Work Order ID 108757

Item Name: Bearpaw Wearplate

DART SERVICE INSTRUCTION

TO AMEND INSTALLATION INSTRUCTIONS D350-578 REV. F OR EARLIER
AND INSTRUCTIONS FOR CONTINUED AIRWORTHINESS ICA-D350-578 REV. 1 OR EARLIER

FIGURE 1: D350-578-031 WEARPLATE KIT

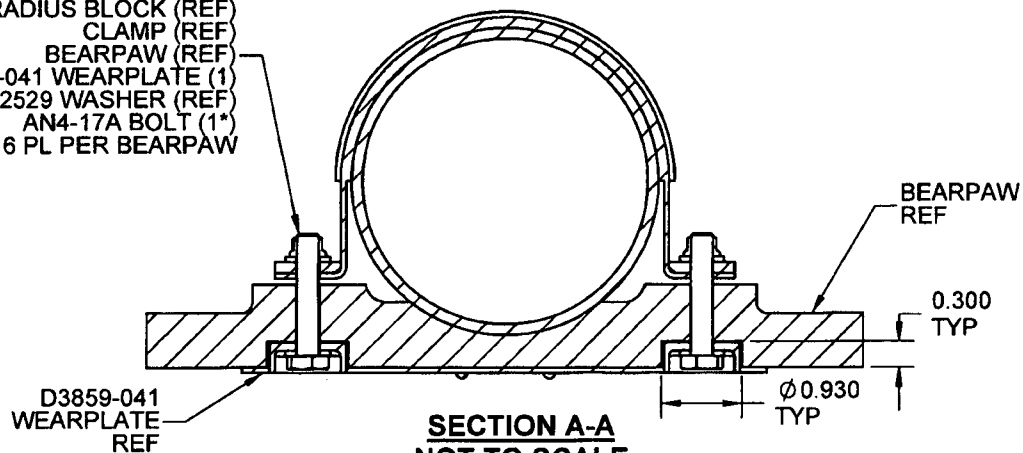
The D350-578-031 Wearplate kit can be installed on D350-578-011/-021 Bearpaw installations. The D3859-041 Wearplates should be installed on the D2432F or D2672F Bearpaws as shown in Figure 1 on Sheet 2 of this Service Instruction. The Bearpaws should otherwise be installed on the skidtube per installation instructions D350-578 Rev F or earlier.

Customers with old style bearpaws will need to rework the counterbore on the bottom of the bearpaws per Figure 1 on Sheet 2 of this service instruction.

* ADDITIONAL NAS1149D0463J WASHERS MAY BE INSTALLED UNDER NUTS TO ENSURE 1.5 - 4 THREADS IN SAFETY ON BOLTS. ALTHOUGH NOT GENERALLY NECESSARY, IT IS ALSO ACCEPTABLE TO REPLACE THE AN4-17A BOLTS WITH LONGER OR SHORTER AN4 BOLTS, IF REQUIRED.
